UNITED STATES PATENT AND TRADEMARK OFFICE

APPLICATION NO.	FILING DATE	FIRST NAMED INVENTOR	ATTORNEY DOCKET NO.	CONFIRMATION NO.
10/030,302	11/09/2001	Johann Herrmann	32860-000196	8998

Office Action Summary

EXAMINER'S
ATTACHMENT
For 10/030302

FIG. 2

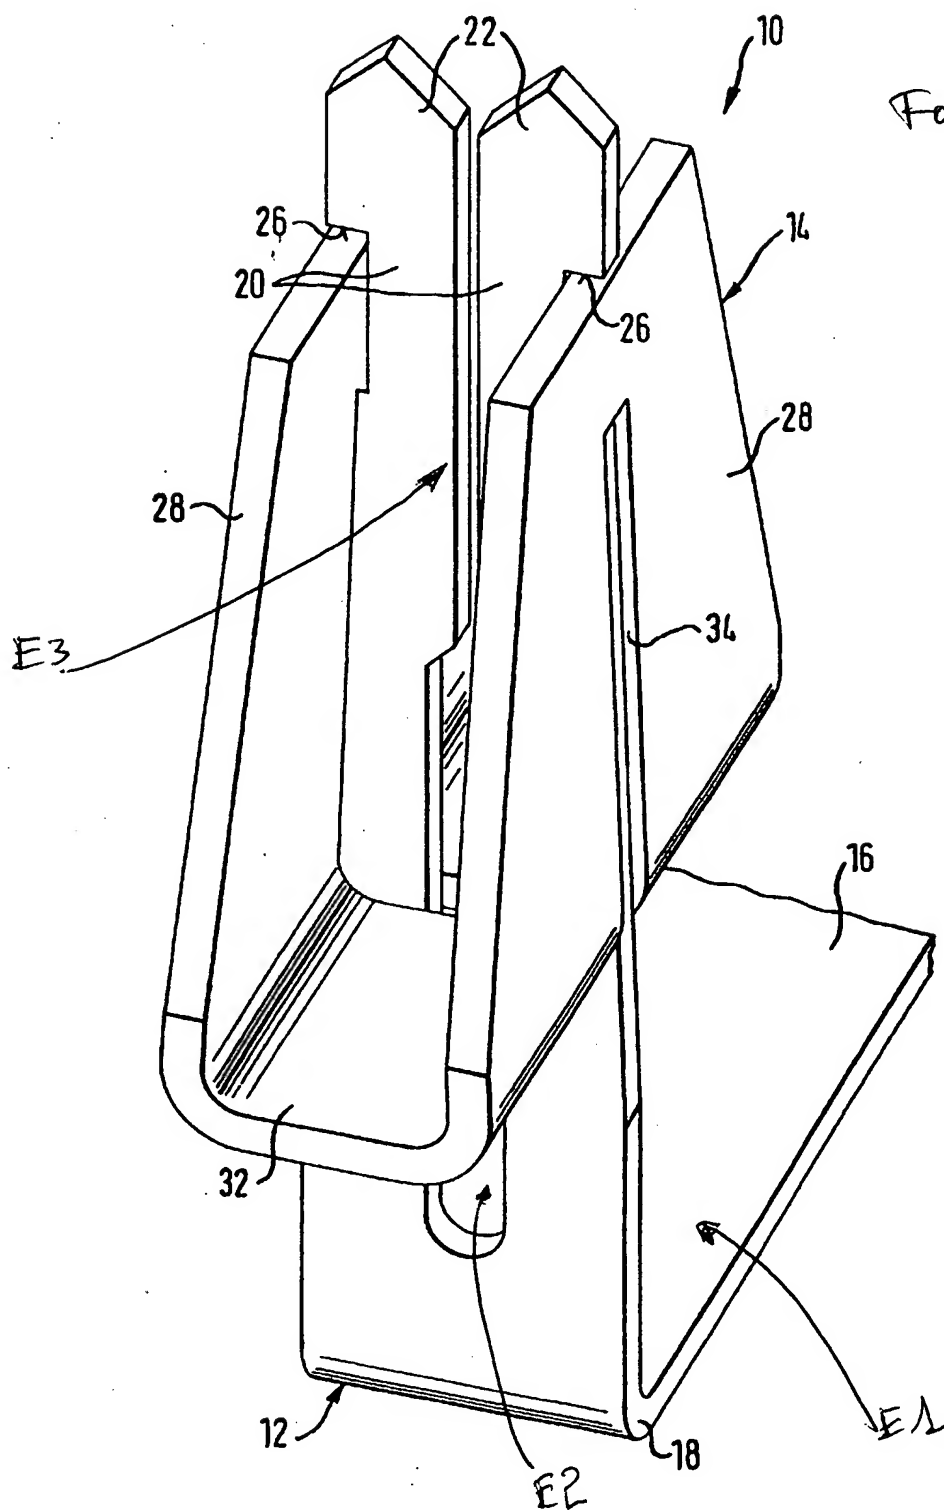
Regarding claim 25, Burmeister et al. disclose an insulation displacement contact (10), comprising:

a bracket (E1), including a contact region (E2) therein; and

at least one spring clip (20) attached to the bracket, wherein the spring clip includes a cutting blade portion (E3) adapted to cut and located proximate to the contact region.

Regarding claim 2, the modified contact of Burmeister et al. discloses a blunt contact zone (E1, see Examiner's attachment).
